CITY OF TAYLOR, TEXAS

PLANNING AND ZONING COMMISSION MEETING

June 14, 2022, 6:00 P.M.

2. **PZ-2021-1281** – Consider disapproving RCR-Taylor Logistics Park Phases 1, 2, and 3 Preliminary Plat, consisting of approximately 756.00 acres of land, addressed as 201 FM 3349, more particularly described by Williamson Central Appraisal District Parcels R019173, R019450, R349685, R435559, R435560, R586971, R586972, R586973, R586974, R605658, R605702, R619617, and R621879, part of and out of the Watkins Nobles Survey, Abstract No. 484 and James C. Eaves Survey, Abstract No. 213, Taylor, Williamson County, Texas.

RCR-Taylor Logistics Park Phases 1, 2,
and 3 Preliminary Plat
201 FM 3349
Approximately 756.00 Acres

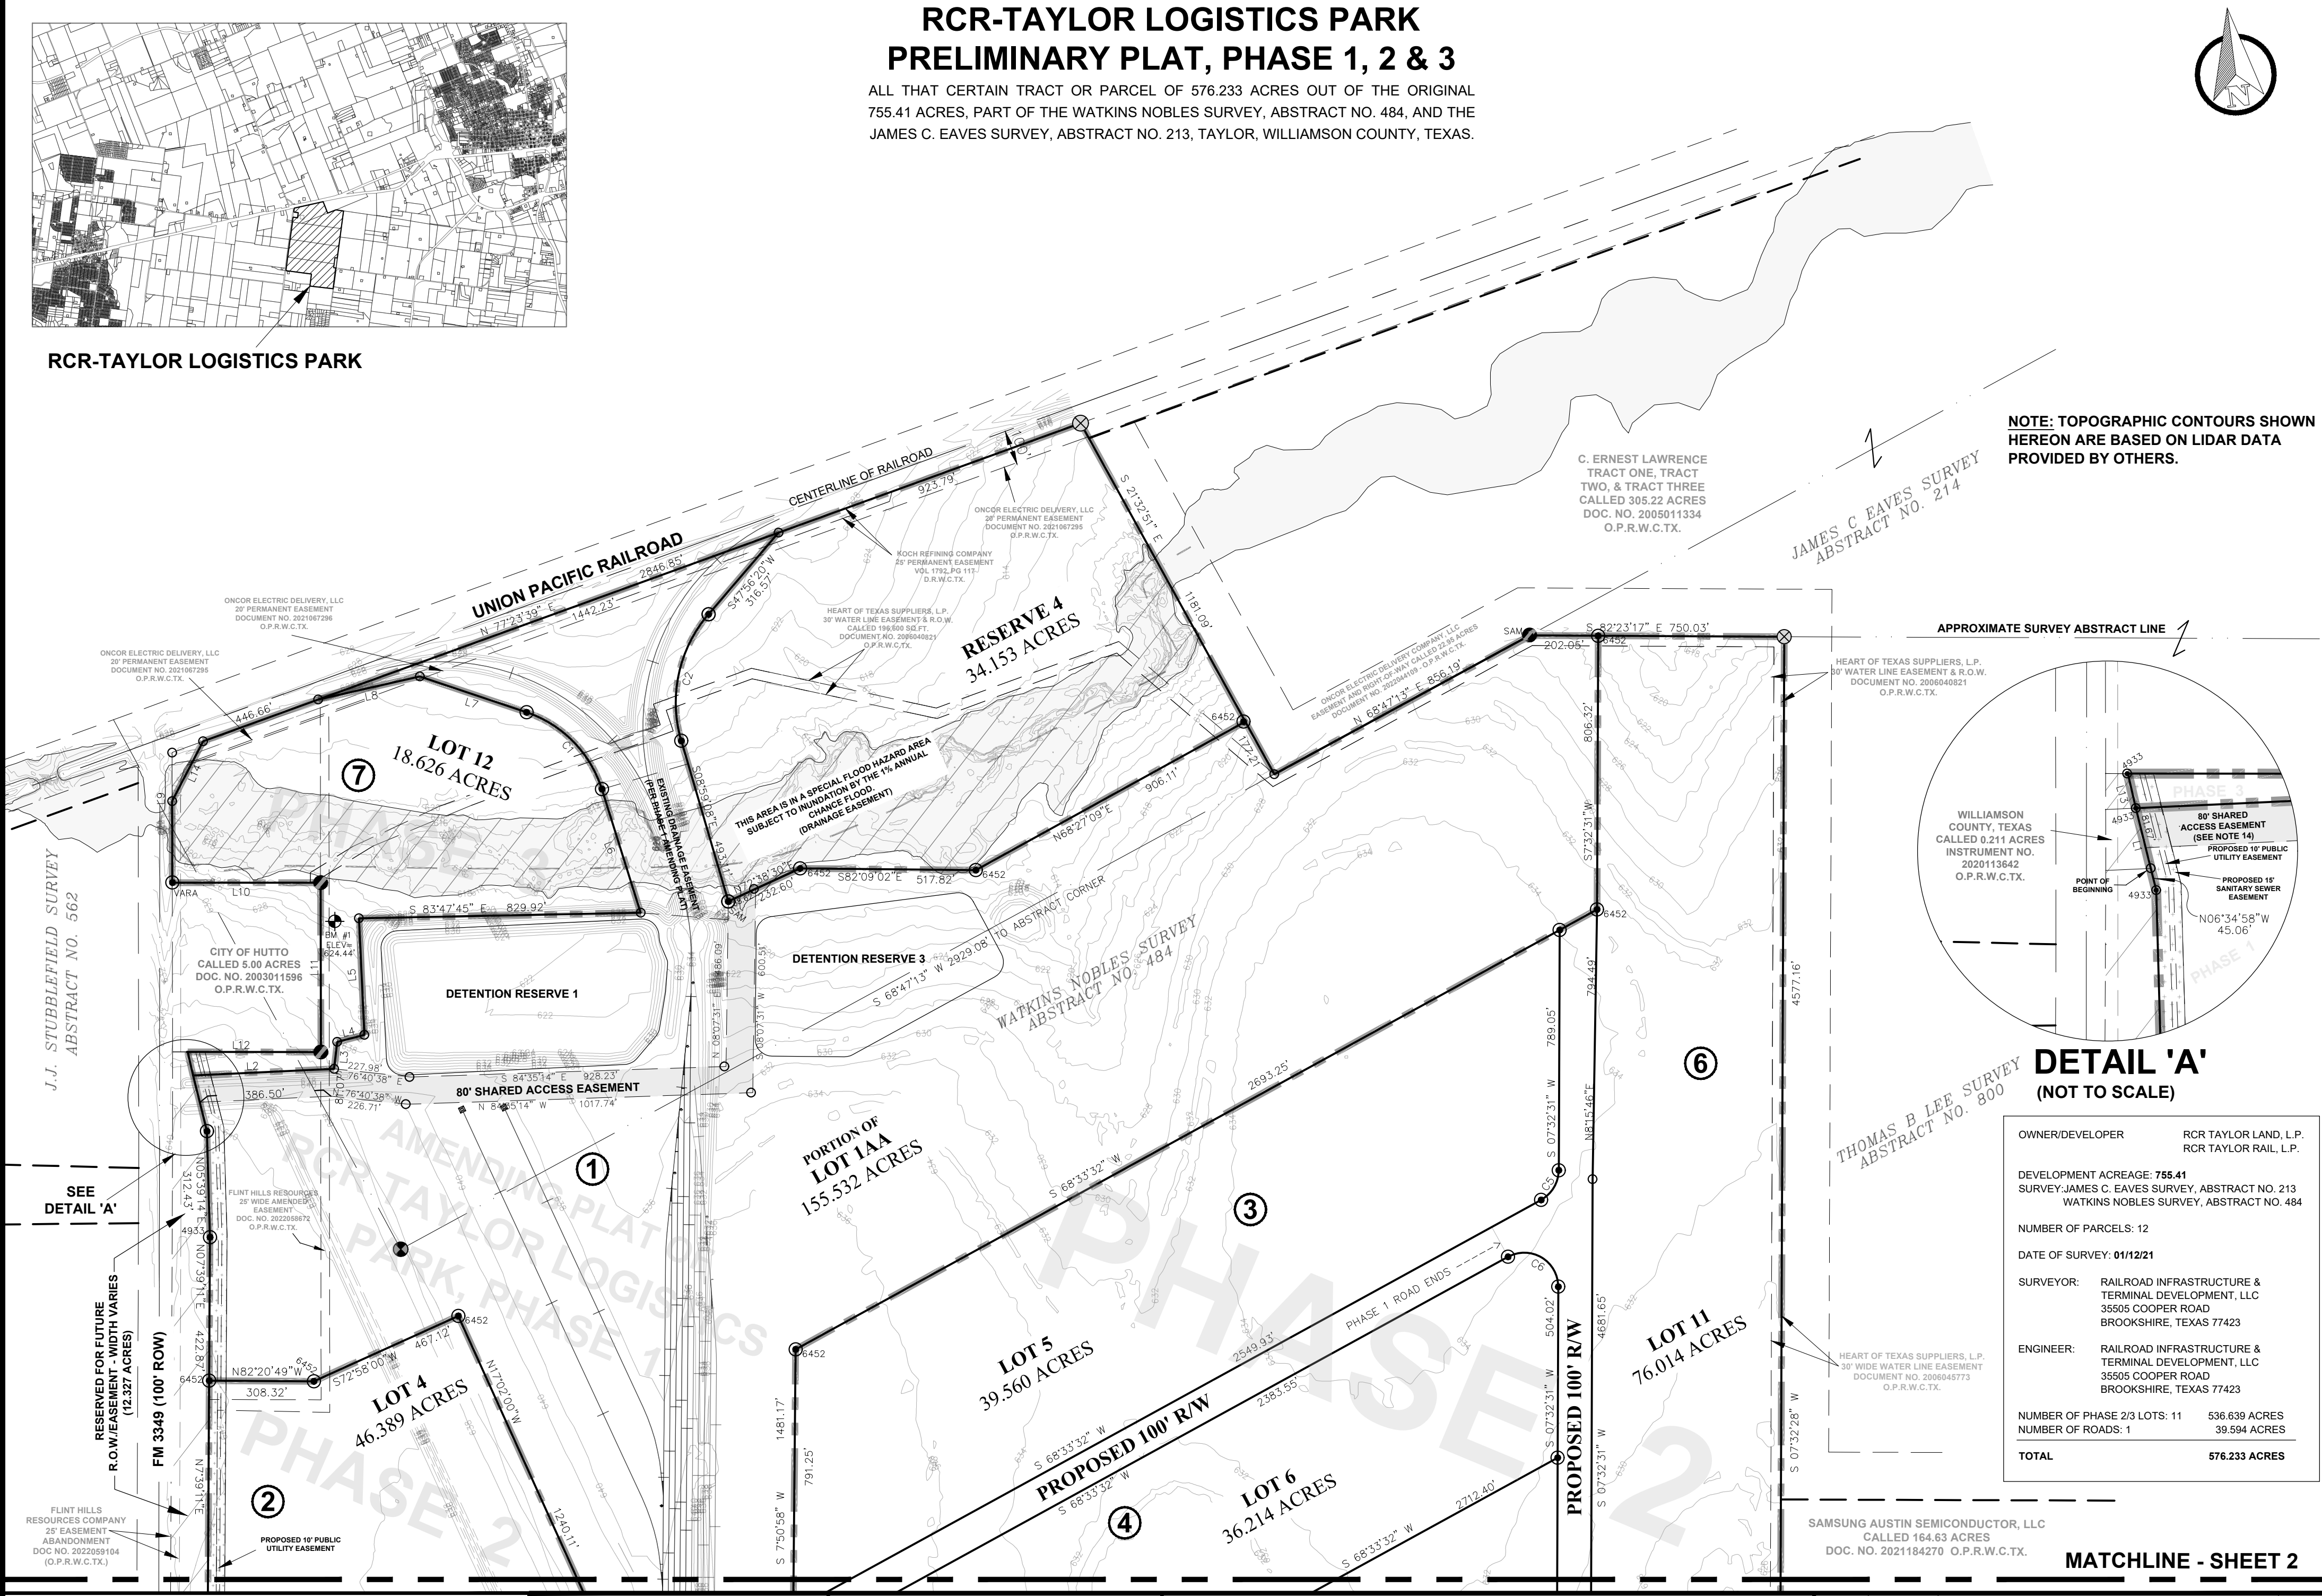
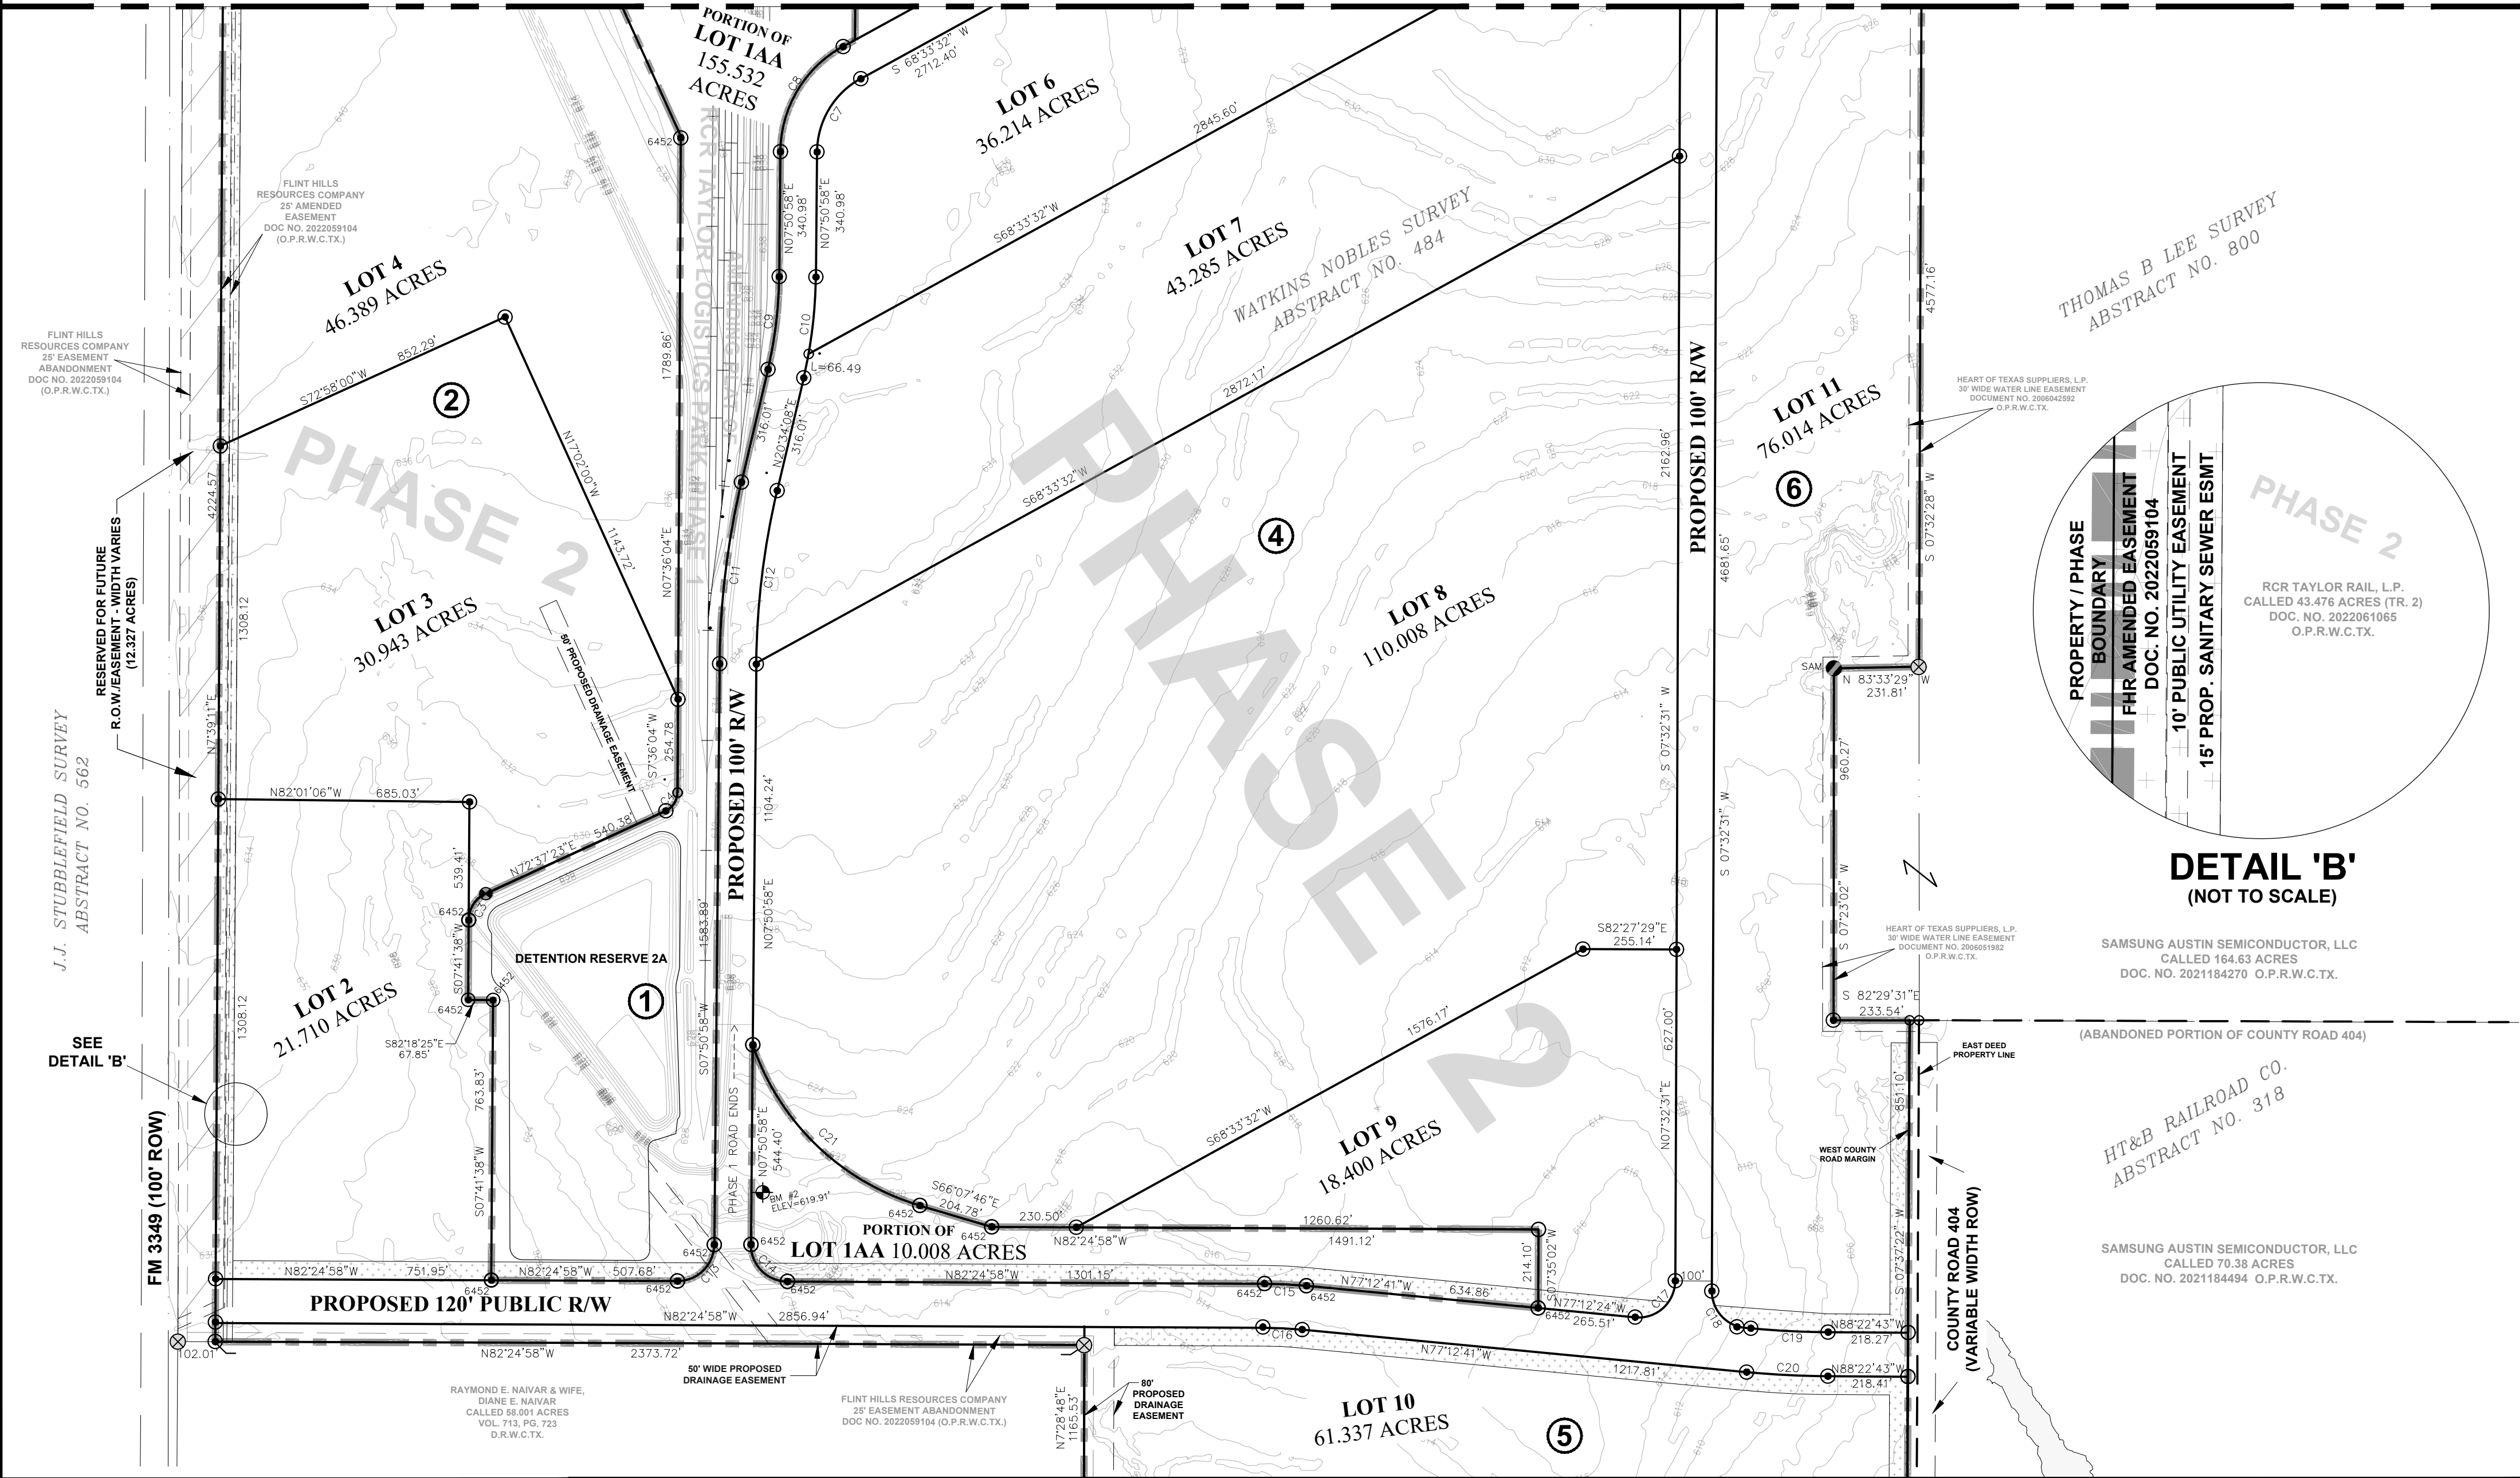
Update 06.08.2022 This comment is still current. The preliminary plat and zone layout need to be consistent with each other.

Updated 06.08.2022 The comment requesting that the sidewalks be shown is still current.

Show sidewalks adjacent to proposed rights-of-way. If sidewalks are not to be provided then that must be proposed in an updated Planned Development ordinance. See ordinance excerpt below:

Provide the deed numbers for the various lots you're proposing on the plat as you have provided them previously for the applications.

Clarify the phasing for infrastructure.
